**WARRANTY
BULLETIN**

Wb09-01

DATE : MARCH 2009	SECTION : 04 - Exhaust
EXPIRATION: MARCH 2011	
SUBJECT : COACHES EXHAUST SYSTEM UPDATE

On the vehicles affected by this bulletin, the exhaust system must be updated in order to modify exhaust fumes path, increase diffuser performance and reflect latest improvement.

FIGURE 1: EXHAUST SYSTEM INSTALLATION WITH DDEC VI ENGINE

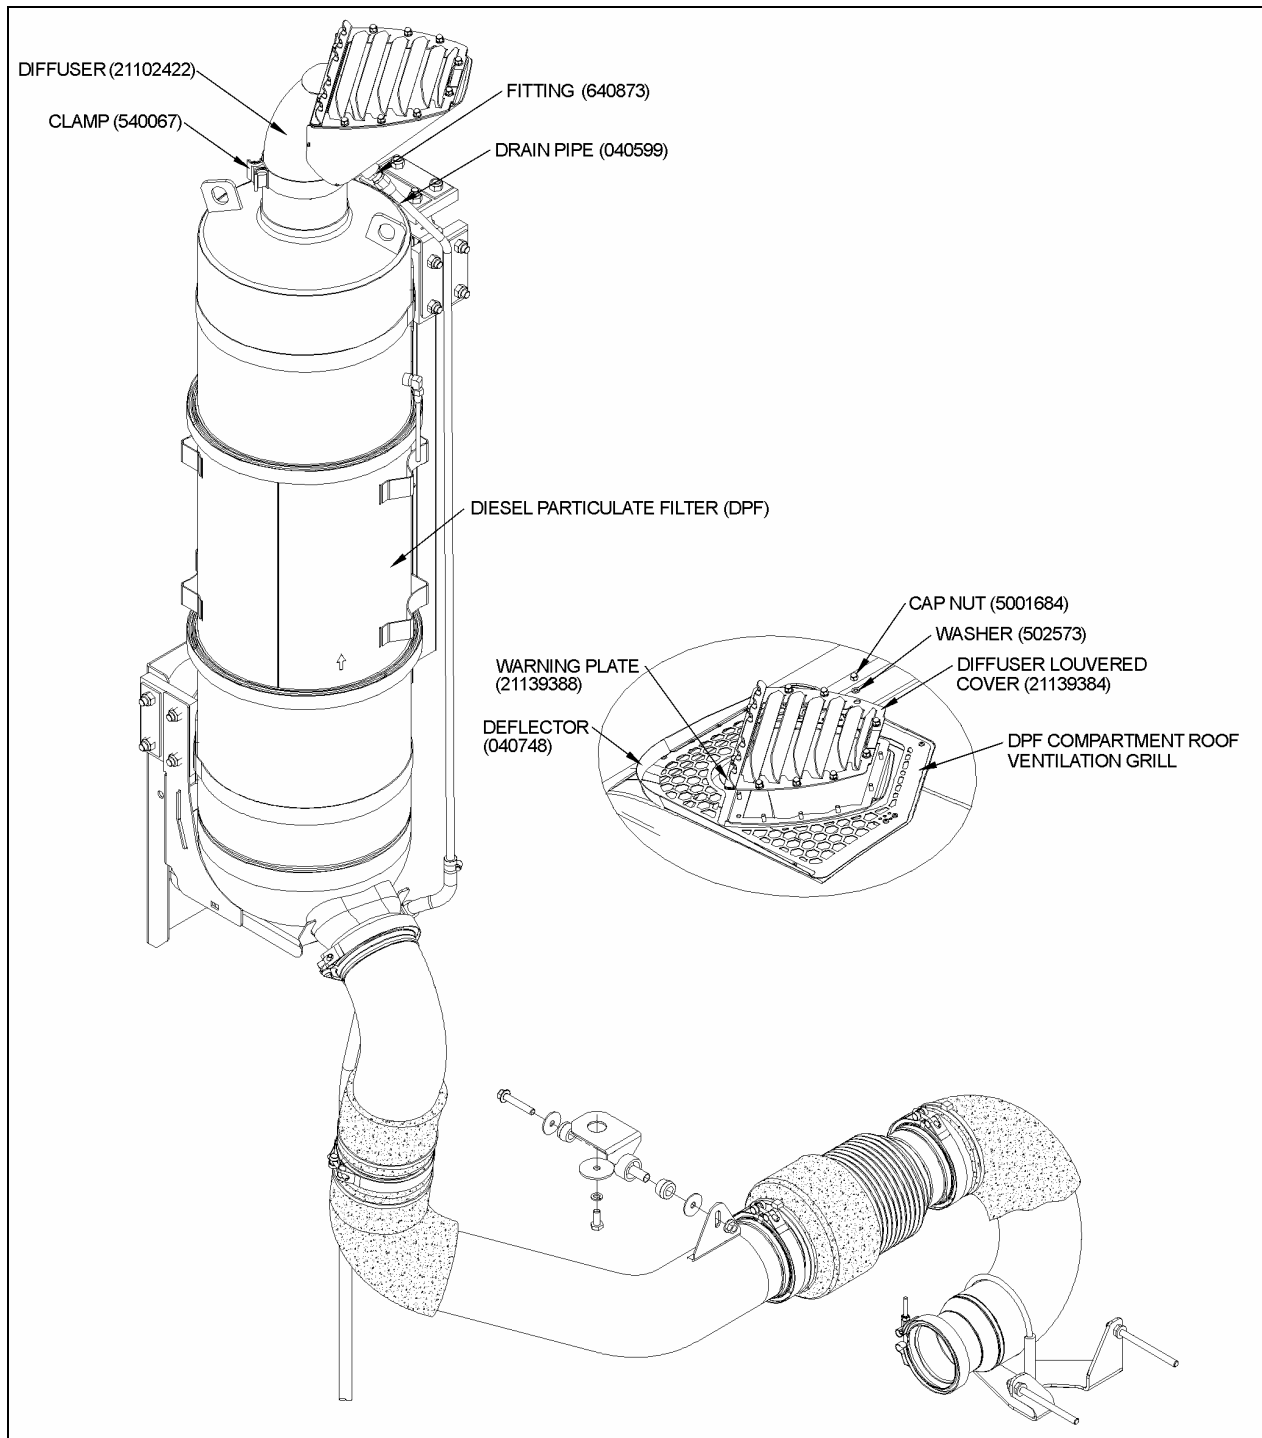
1. Open Diesel Particulate Filter (DPF) compartment access door.
2. Remove DPF compartment roof ventilation grill and put aside (refer to fig. 1 or 2).
3. Remove diffuser holding clamp located above diesel particulate filter (refer to fig. 1 or 2).
4. Unfasten diffuser drain pipe fitting and then remove drain pipe (refer to fig. 1 or 2).
5. Replace current diffuser with diffuser (21102422) equipped with welded screen.
6. Position Diesel Particulate Filter (DPF) compartment roof ventilation grill and then fix new deflector (040748) and roof ventilation grill using screws (refer to fig. 1 or 2).
7. Secure diffuser using SS holding clamp (540067) (refer to fig. 1 or 2).

Height of diffuser must be adjusted so that it is flush with or exceeds by ¼ inch (6 mm) maximum the rear cap exterior surface.

8. Replace copper drain pipe with SS pipe (040599) and secure to diffuser using new pipe fitting (640873) (refer to fig. 1 or 2).

9. Fix diffuser louvered cover (21139384) as well as warning plate (21139388) onto diffuser using flat washers (502573) and cap nuts (5001684) (refer to fig. 1 or 2).

FIGURE 2: EXHAUST SYSTEM INSTALLATION WITH VOLVO D13 ENGINE

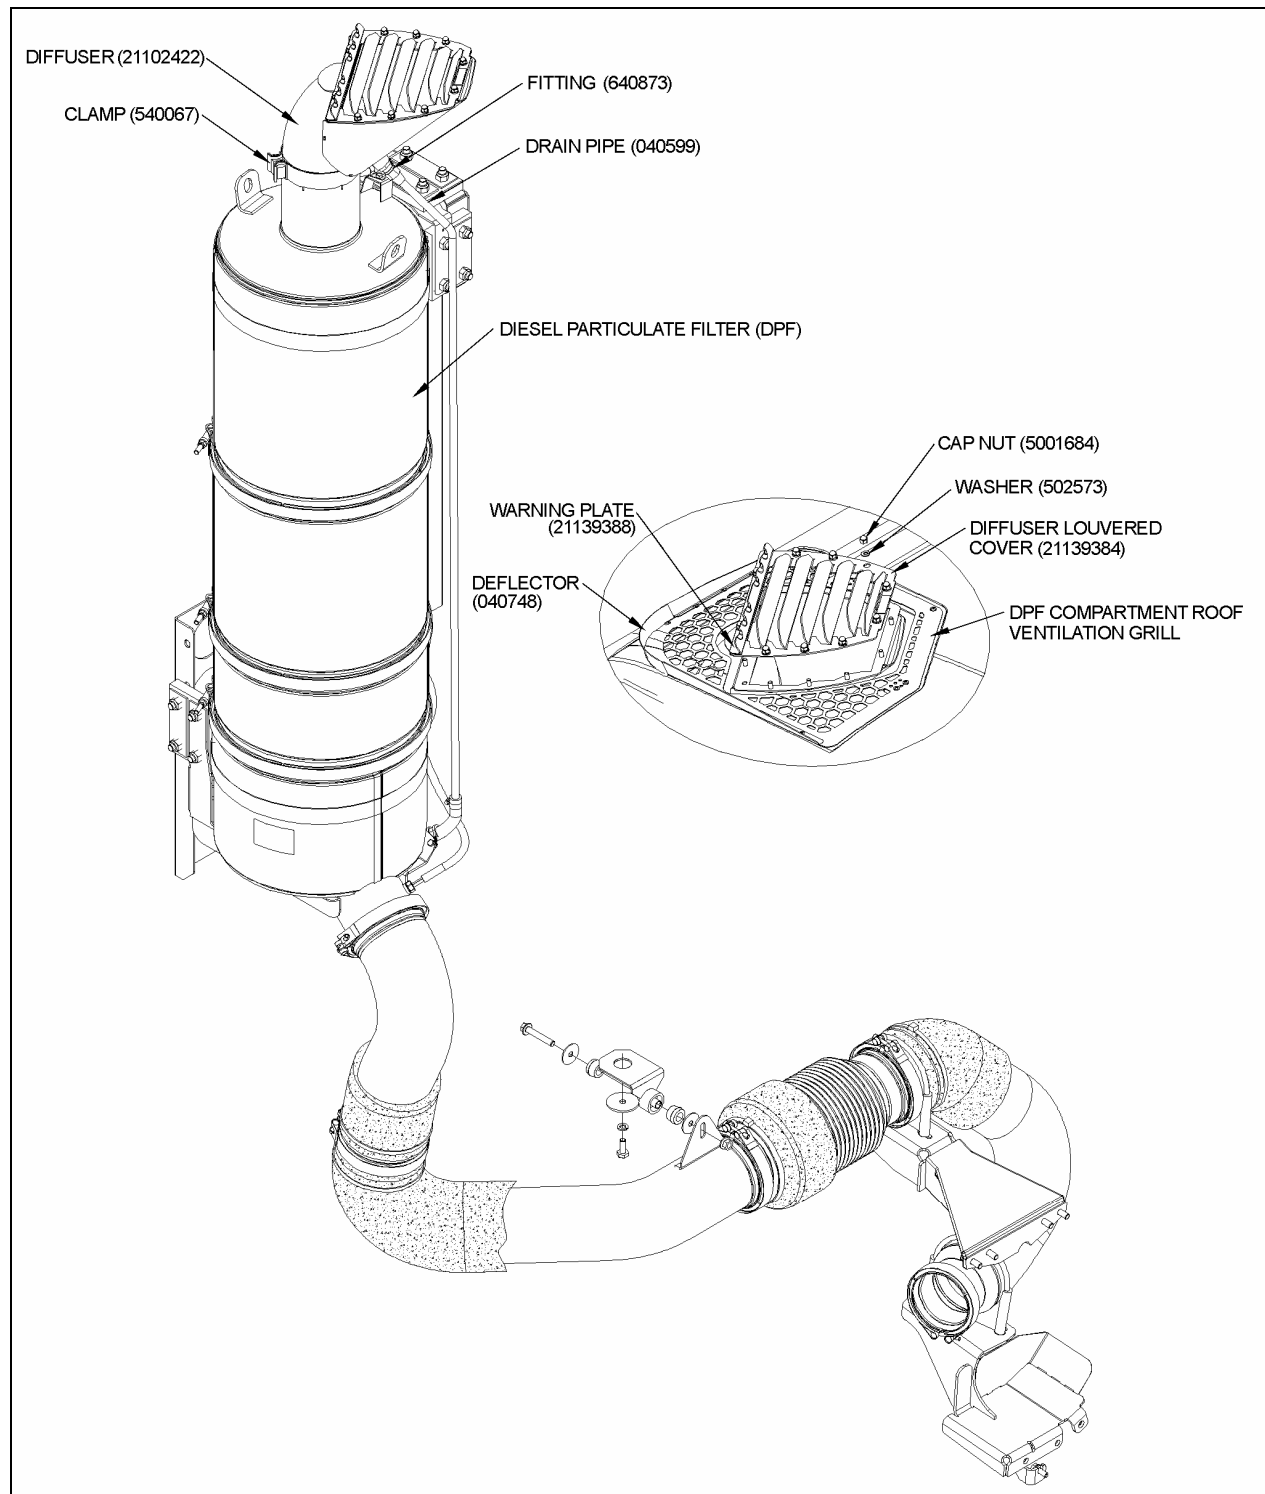
1. Open Diesel Particulate Filter (DPF) compartment access door.
2. Remove DPF compartment roof ventilation grill and put aside (refer to fig. 1 or 2).
3. Remove diffuser holding clamp located above diesel particulate filter (refer to fig. 2).
4. Unfasten diffuser drain pipe fitting (refer to fig. 2).
5. Replace current diffuser with diffuser (21102422) equipped with welded screen.
6. Position Diesel Particulate Filter (DPF) compartment roof ventilation grill and then fix new deflector (040748) and roof ventilation grill using screws (refer to fig. 2).
7. Secure diffuser using SS holding clamp (540067) (refer to fig. 2).

Height of diffuser must be adjusted so that it is flush with or exceeds by ¼ inch (6 mm) maximum the rear cap exterior surface.

8. Reconnect drain pipe to diffuser using pipe fitting (refer to fig. 2).
9. Fix diffuser louvered cover (21139384) as well as warning plate onto diffuser using flat washers (502573) and cap nuts (5001684) (refer to fig. 2).

FIGURE 3: EXHAUST SYSTEM INSTALLATION WITH DDEC VI ENGINE

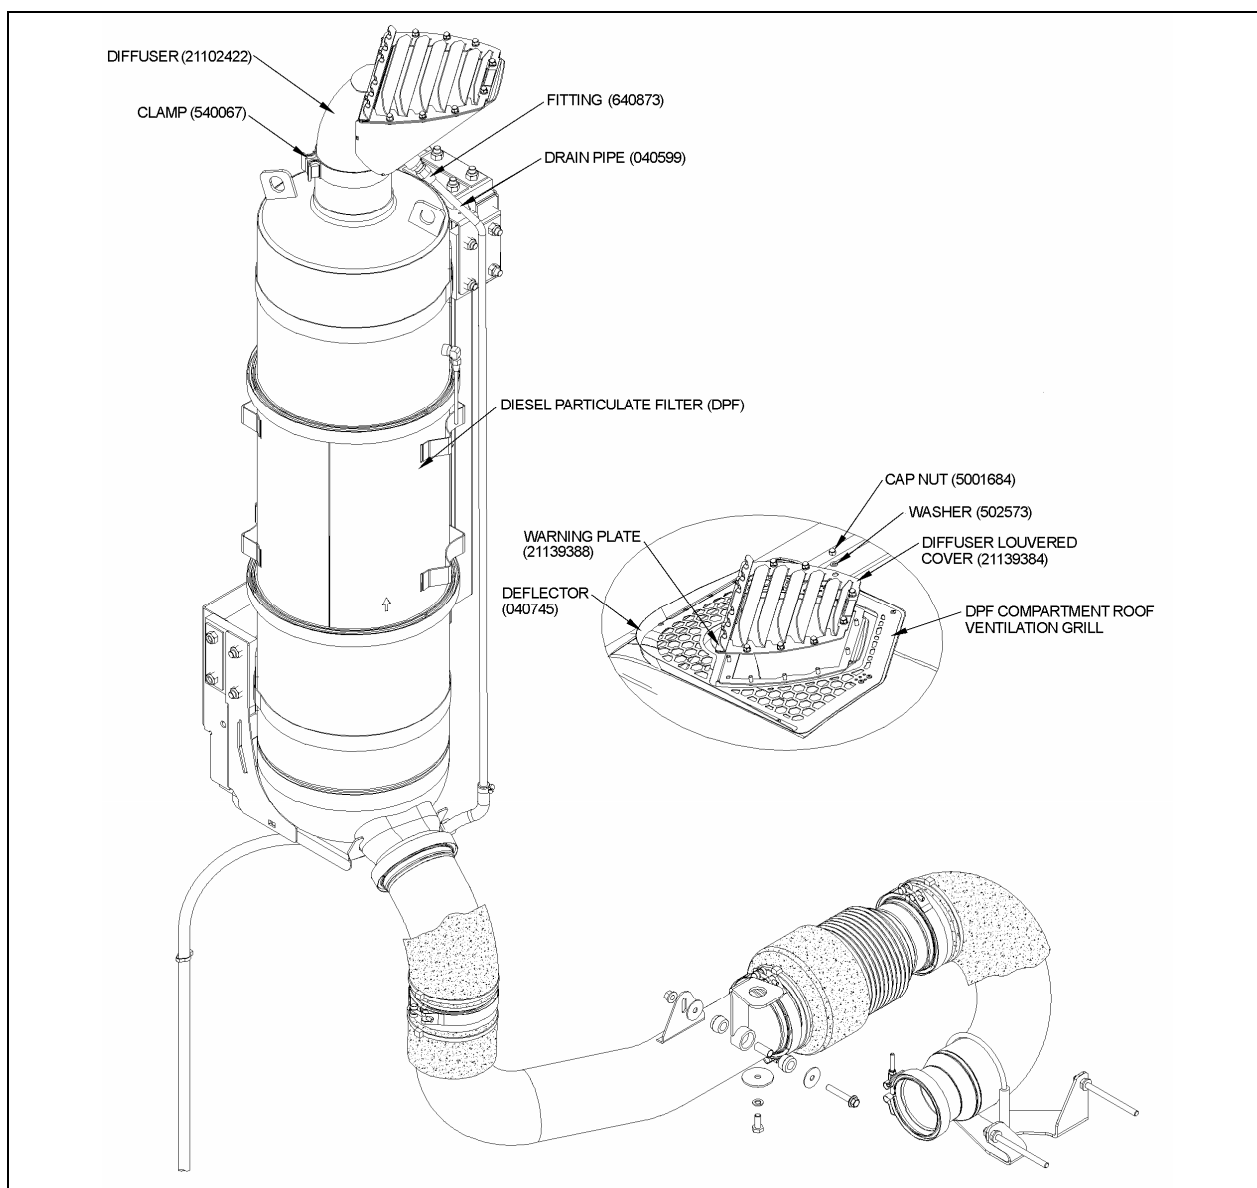
1. Open Diesel Particulate Filter (DPF) compartment access door.
2. Remove DPF compartment roof ventilation grill and put aside (refer to fig. 3 or 4).
3. Remove diffuser holding clamp located above diesel particulate filter (refer to fig. 3 or 4).
4. Unfasten diffuser drain pipe fitting and then remove drain pipe (refer to fig. 3 or 4).

5. Replace current diffuser with diffuser (21102422) equipped with welded screen.
6. Position Diesel Particulate Filter (DPF) compartment roof ventilation grill and then fix new deflector (040745) and roof ventilation grill using screws (refer to fig. 3 or 4).
7. Secure diffuser using SS holding clamp (540067) (refer to fig. 3 or 4).

Height of diffuser must be adjusted so that it is flush with or exceeds by ¼ inch (6 mm) maximum the rear cap exterior surface.

8. Replace copper drain pipe with SS pipe (040599) and secure to diffuser using new pipe fitting (640873) (refer to fig. 3 or 4).
9. Fix diffuser louvered cover (21139384) as well as warning plate (21139388) onto diffuser using flat washers (502573) and cap nuts (5001684) (refer to fig. 3 or 4).

FIGURE 4: EXHAUST SYSTEM INSTALLATION WITH VOLVO D13 ENGINE

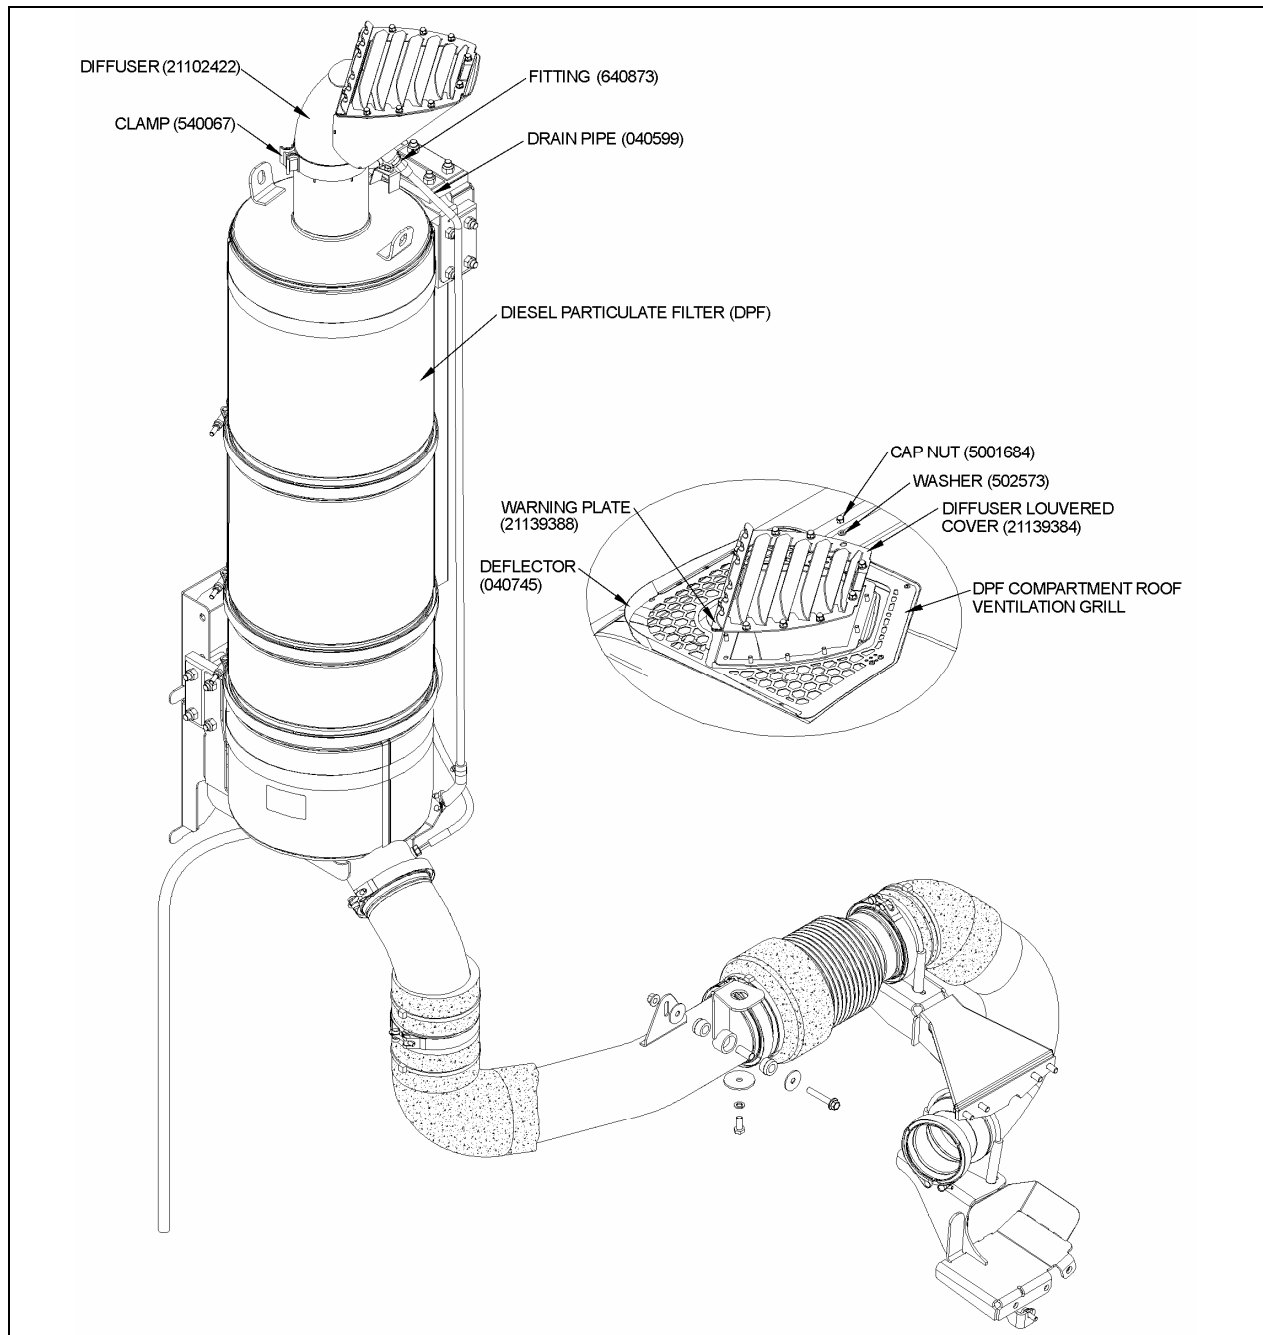
1. Open Diesel Particulate Filter (DPF) compartment access door.
2. Remove DPF compartment roof ventilation grill and put aside (refer to fig. 3 or 4).
3. Remove diffuser holding clamp located above diesel particulate filter (refer to fig. 3 or 4).
4. Unfasten diffuser drain pipe fitting (refer to fig. 3 or 4).

5. Replace current diffuser with diffuser (21102422) equipped with welded screen.
6. Position Diesel Particulate Filter (DPF) compartment roof ventilation grill and then fix new deflector (040745) and roof ventilation grill using screws (refer to fig. 3 or 4).
7. Secure diffuser using SS holding clamp (refer to fig. 3 or 4).

Height of diffuser must be adjusted so that it is flush with or exceeds by ¼ inch (6 mm) maximum the rear cap exterior surface.

8. Reconnect drain pipe to diffuser using pipe fitting (refer to fig. 3 or 4).
9. Fix diffuser louvered cover (21139384) as well as warning plate (21139388) onto diffuser using flat washers (502573) and cap nuts (5001684) (refer to fig. 3 or 4).
